Appl. No. 10/063,868

**Amendments to the Drawings**

*Annotated Sheet*  
Inventor: David Crist Gabriel  
Serial No.: 10/063,868  
For: Diagnostic Method for an Electric Drive Assembly  
Attorney Doc. No.: 201-0268

Figure 1

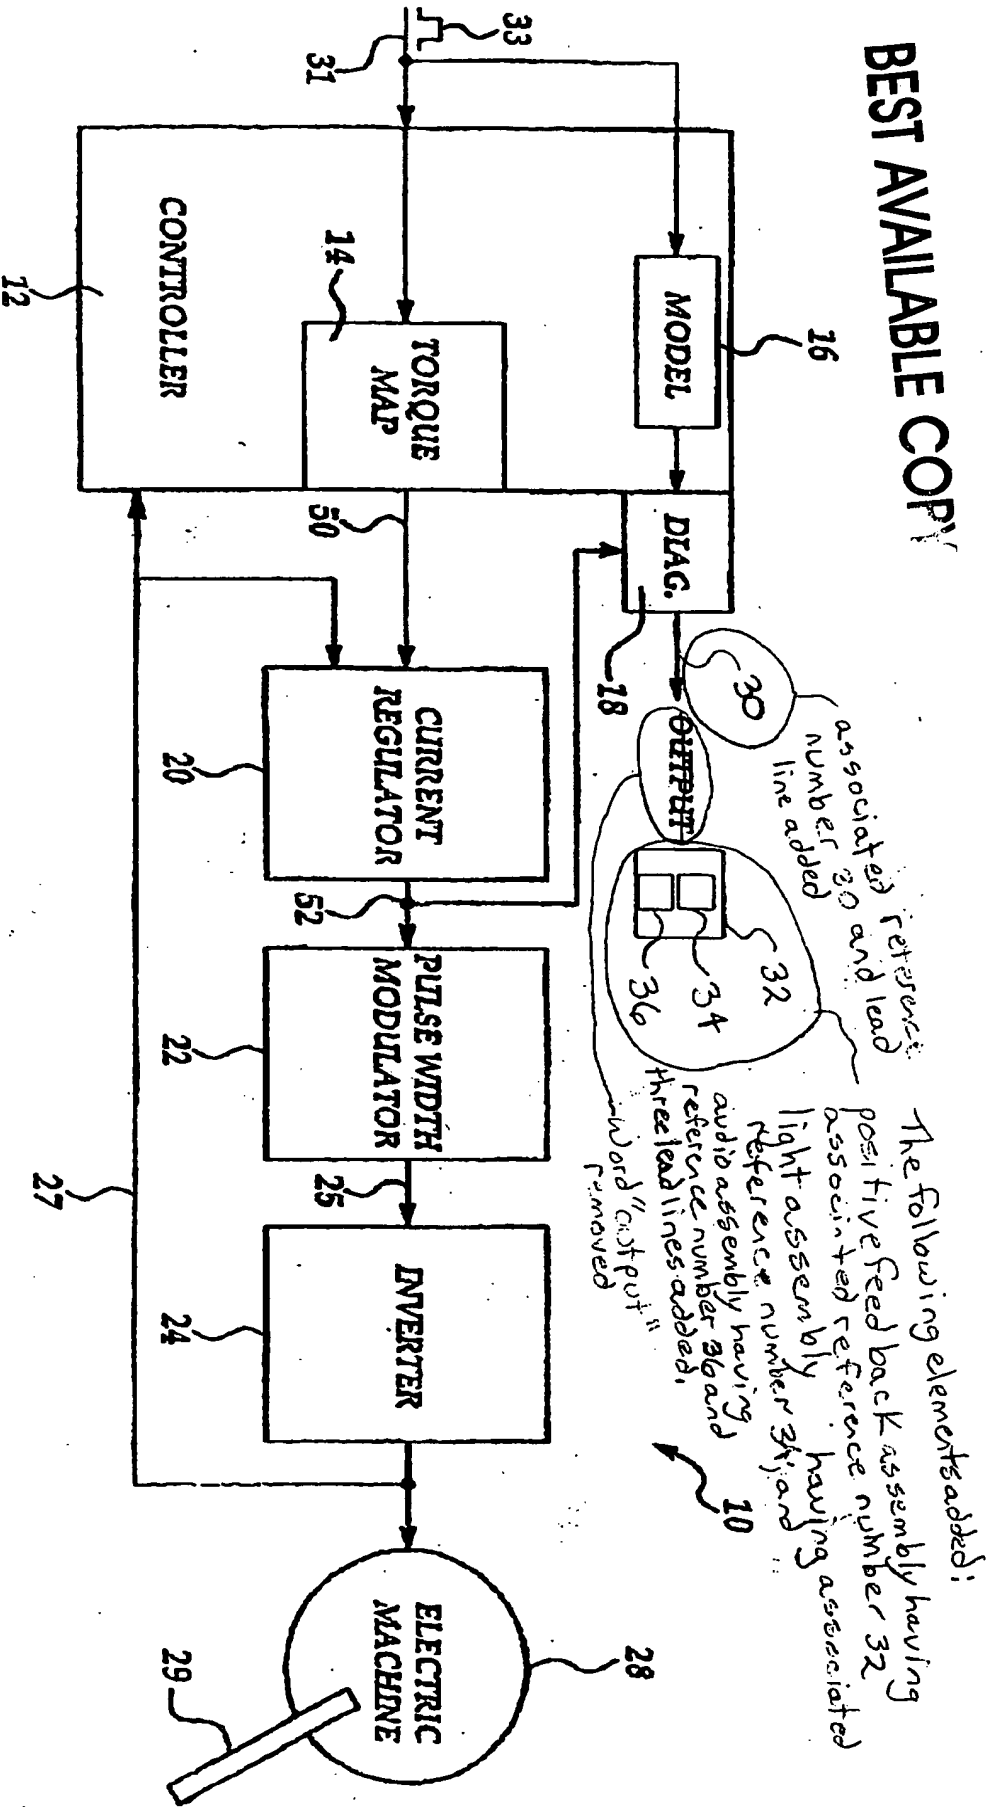
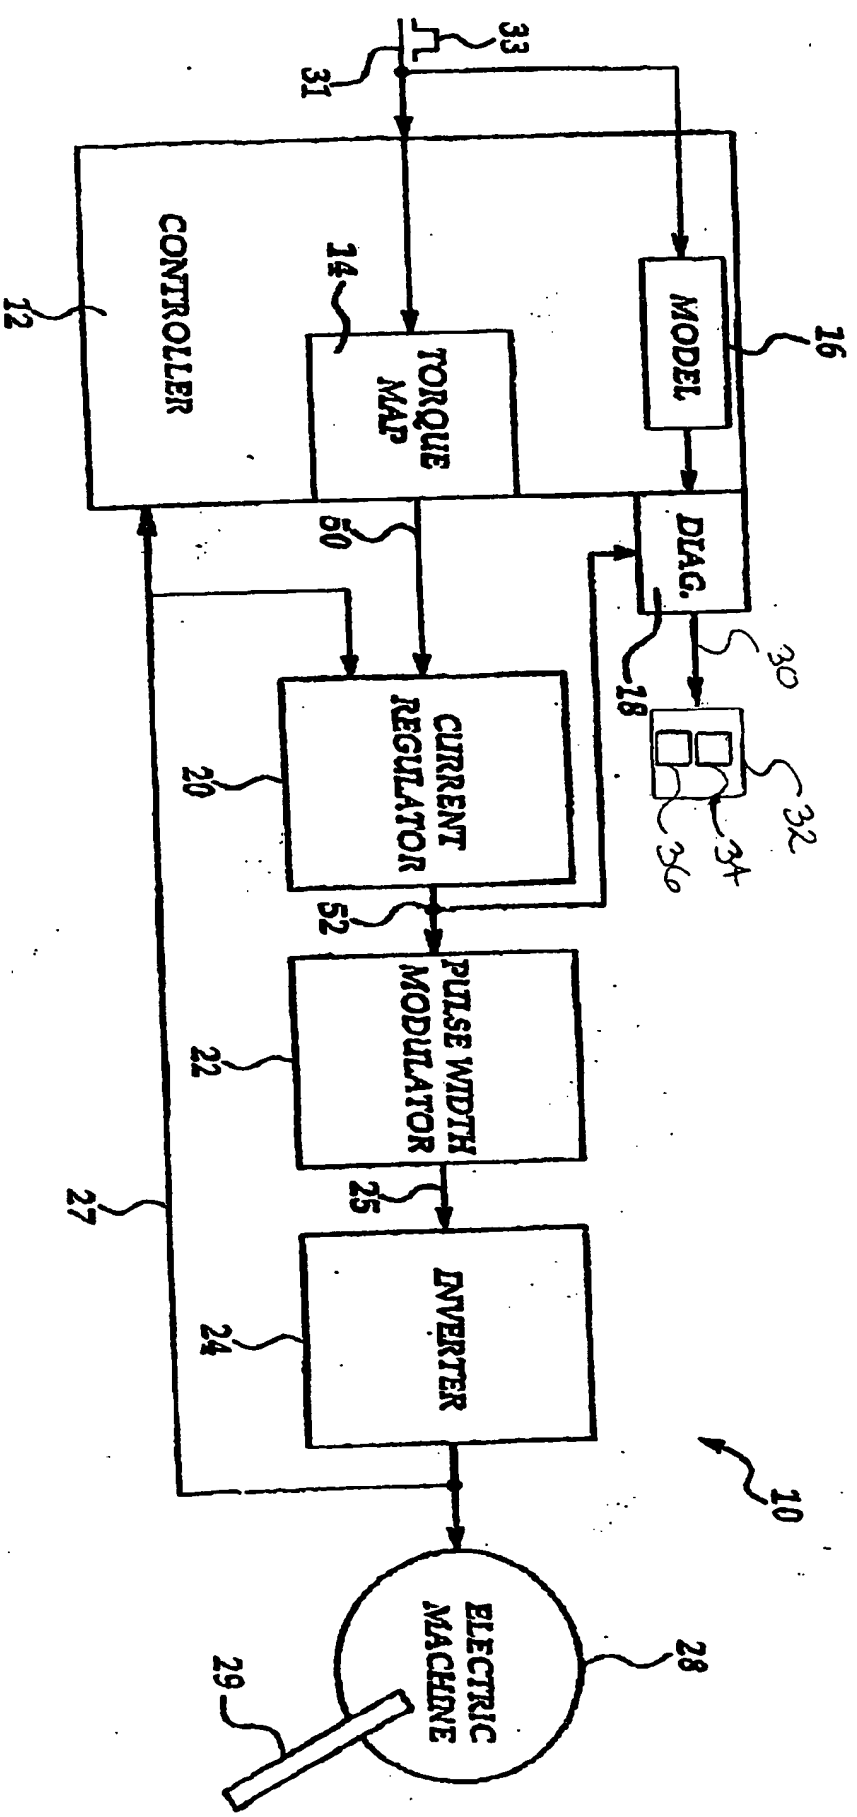
The attached sheet of drawings includes changes to Figure 1. This sheet, which includes Figure 1, replaces the original sheet including Figure 1. In amended Figure 1, a reference number 30 depicting a diagnostic output signal having an associated lead line has been added as disclosed in Pending Application, page 11, line 20, and the word "OUTPUT" has been removed. Additionally, a positive feed back assembly having associated reference number "32" and lead line has been added as disclosed in Pending Application, page 11, lines 21-22. Also, both a selectively energizable light assembly having an associated reference number "34" and lead line has been added as disclosed in Pending Application, page 12, lines 3-4; and a selectively energizable audio assembly having an associated reference number "36" and lead line has been added as disclosed in Pending Application, page 12, lines 4-5.
